Chester Upland School District Toby Farms Intermediate School

Renovations

Addenda No. 05

Issued 04-17-23

Preliminary Phasing Plan F - April 5, 2023

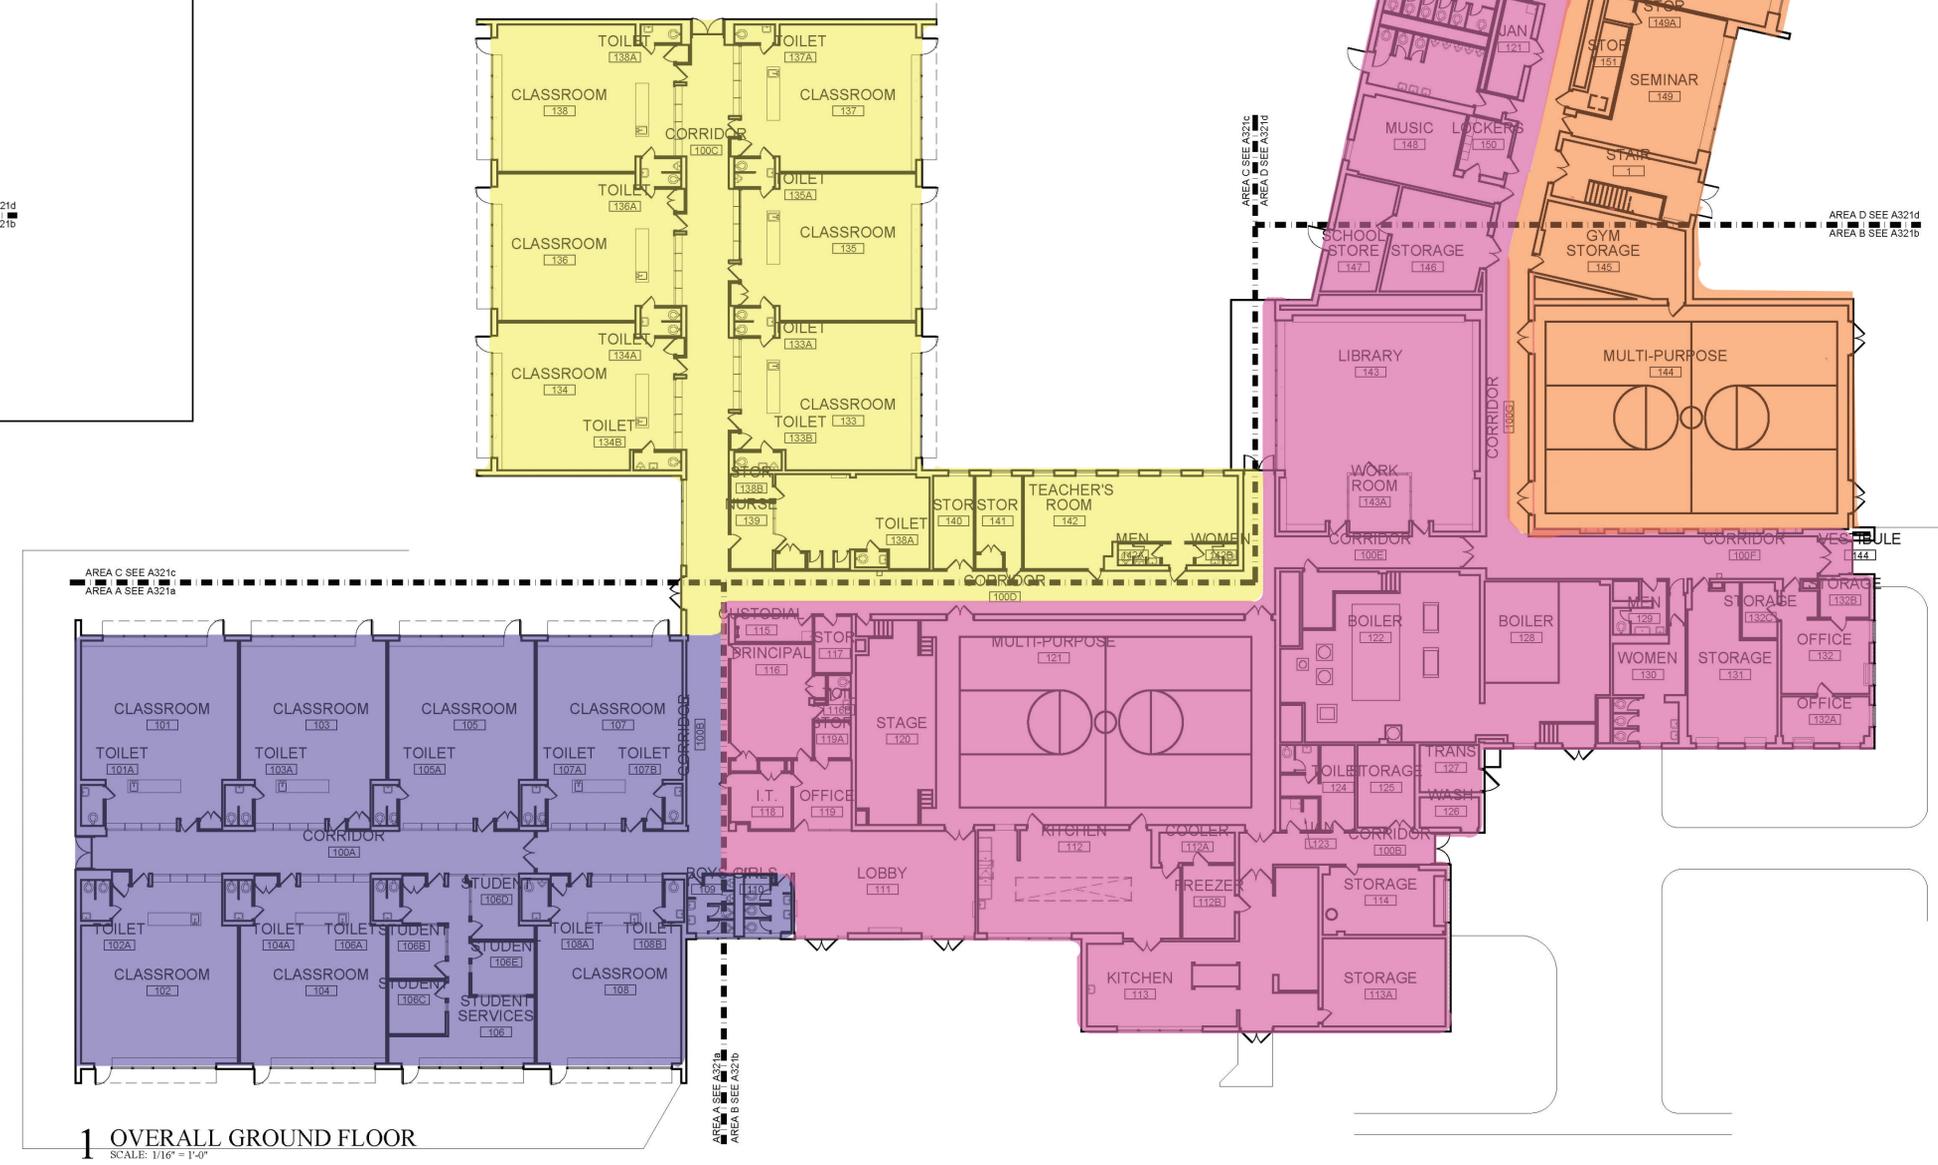
- **Roof Framing drawings uploaded for reference.**
- **Revised Phasing Plan F: The wrong phasing plan was uploaded with addenda 02, this has been corrected.**
